# PCN-20210621 TEB0911-04 eMMC Change and Product Update

<b>Company</b>	Trenz Electronic GmbH
<b>PCN Number</b>	PCN-20210621
<b>Title</b>	TEB0911-04 eMMC Change and Product Update
<b>Subject</b>	BOM change
<b>Issue Date</b>	2021-10-12

This change affects all Trenz Electronic TEB0911 boards of revision 04: TEB0911-04

## #7 Set S/N to not fitted

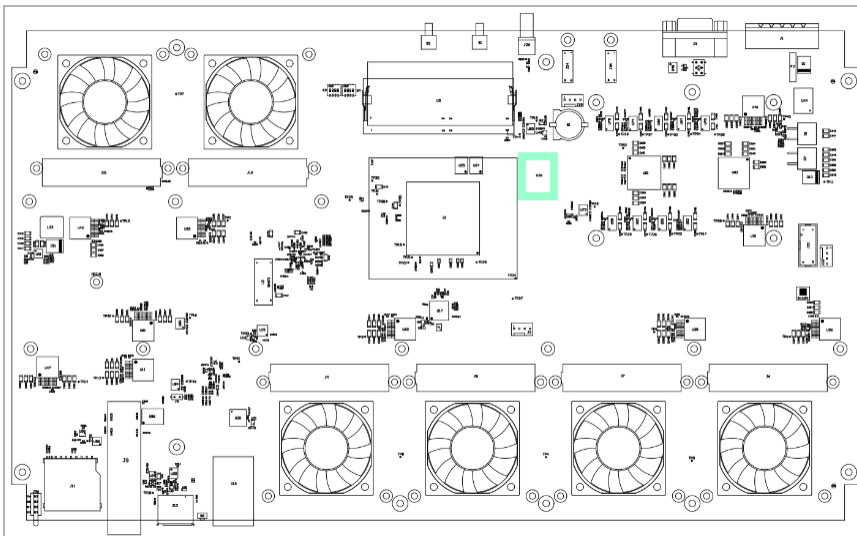
**Type:** BOM change

**Reason:** Part is end of life.

**Impact:** Track it pad no more available.
